# Access Compliance Report

## Public Rights-of-Way

| Intersection ID: 8573                   | Main Street: N_GRAHAM_ST | Cross Street: ATANDO_AV | Location: NE                            |
| ADA ID: 2A27EBC2B987                    | Ramp Type: Para          | Initial Pass/Fail: Pass | Overall Compliance: No                  |

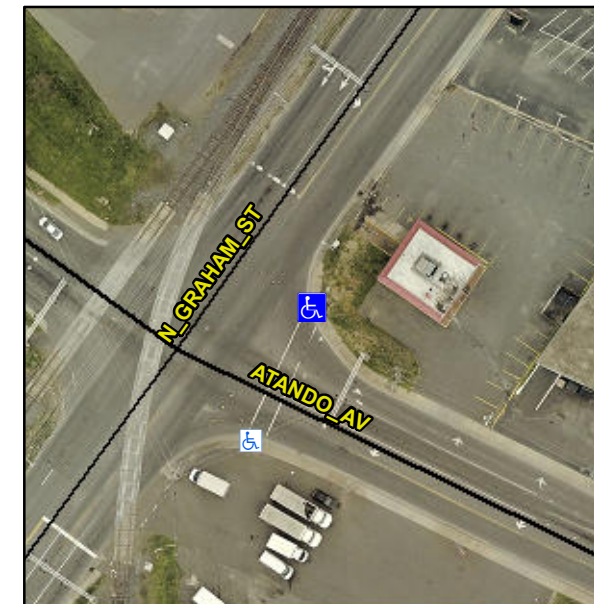
**RT RP < 5%**

**Not Found, R304.2.1, R304.2.2-Perp,  
R304.3.2-Para**

| Compliance | Description          | Data  | Compliance | Description                 | Data |
|------------|----------------------|-------|------------|-----------------------------|------|
| No         | Landing Width (in)   | 43.0  | Yes        | DWS Contrast?               | Yes  |
| No         | Landing Slope (%)    | 2.3   | Yes        | DWS Length (in)             | 25.0 |
|            |                      |       | Replace    | Curb Slope (%)              | 29.1 |

**Remove & Replace Entire Ramp.**
